Revision to a Request for a Standing Offer

Title - Sujet New Workstations Phase 2		
Solicitation No. - N° de l'invitation EP837-171633/A		Date 2017-01-20
Client Reference No. - N° de référence du client 20171633		Amendment No. - N° modif. 006
File No. - N° de dossier pq979.EP837-171633	CCC No./N° CCC - FMS No./N° VME	
GETS Reference No. - N° de référence de SEAG PW-\$\$PQ-982-72081		
Date of Original Request for Standing Offer Date de la demande de l'offre à commandes originale		2016-12-14
Solicitation Closes - L'invitation prend fin at - à 02:00 PM on - le 2017-02-01		Time Zone Fuseau horaire Eastern Standard Time EST
Address Enquiries to: - Adresser toutes questions à: Marton, Andrew		Buyer Id - Id de l'acheteur pq979
Telephone No. - N° de téléphone (613) 220-4845 ()	FAX No. - N° de FAX () -	
Delivery Required - Livraison exigée		
Destination - of Goods, Services, and Construction: Destination - des biens, services et construction:		
Security - Sécurité This revision does not change the security requirements of the Offer. Cette révision ne change pas les besoins en matière de sécurité de la présente offre.

This amendment 006 is raised for the following:

- A) To replace Annex A

FIXED WORKSTATION 4.5m² – ORIENTATION 1

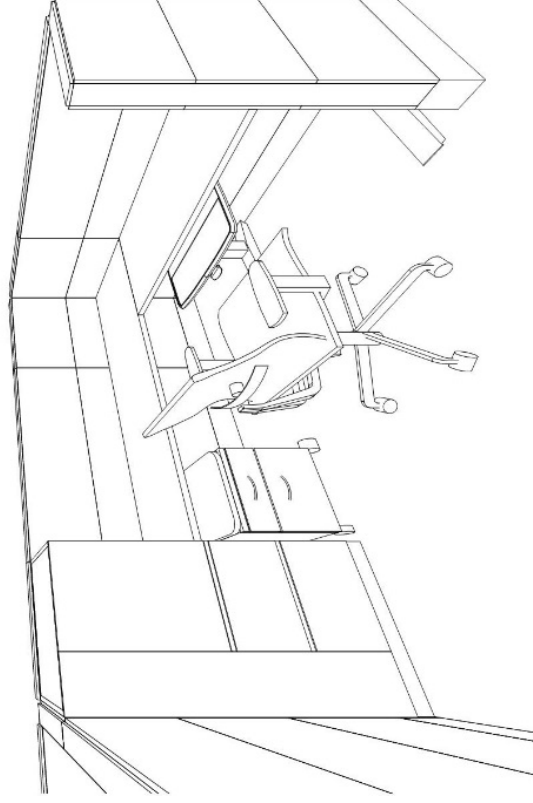
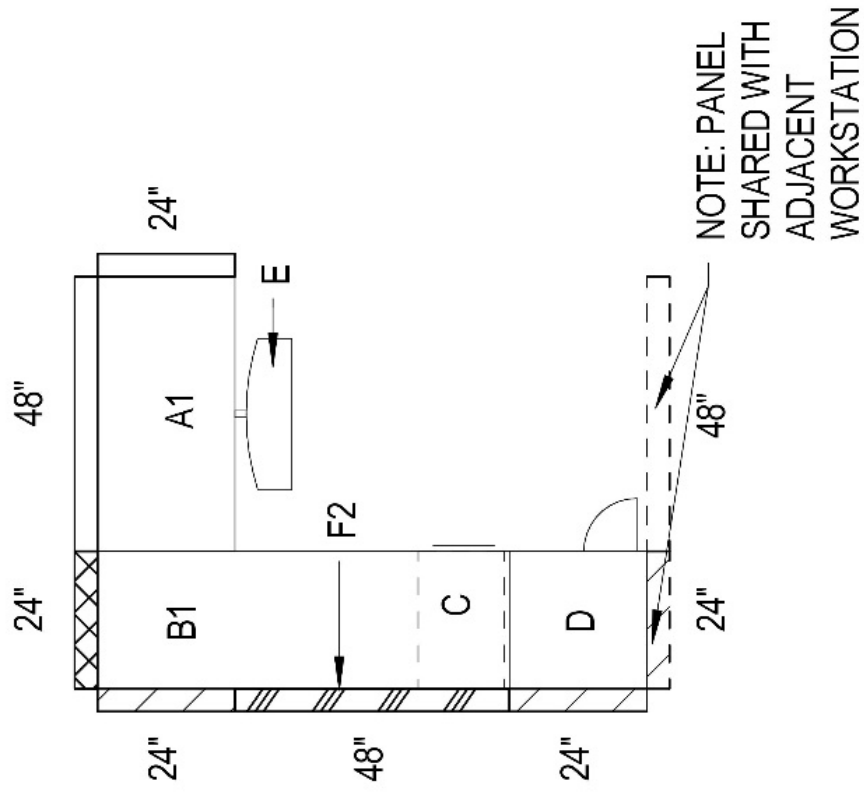
Q14. Annex A-2. In the workstation legend, B1 is referenced as a (610mm D x 1829mm W (24” x 72”), free-standing, height-adjustable (HA) work surface) but in the drawing (T-3, T-4 & T-5) B1 seem to be panel hung. Can you please confirm if B1 is Freestanding or Panel Hung?

A14. Please see Annex A-2 Typical Workstation Layouts and 3d Views Version 2 that has been uploaded as part of this amendment.

FIXED WORKSTATION 4.5m² – ORIENTATION 1 BULLPEN

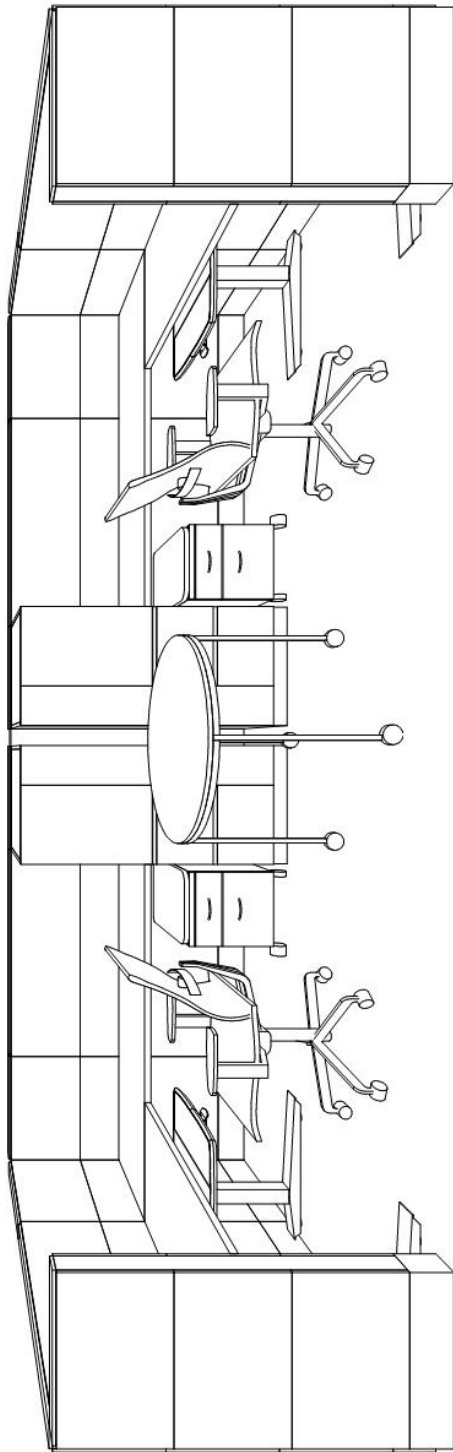
The only difference in T5 versus T6 follows;

T5 uses T3 Fixed Orientation 1 without the panels between stations to create a “bullpen”.

T6 uses T4 Fixed Orientation 2 without the panels between stations to create a “bullpen”.
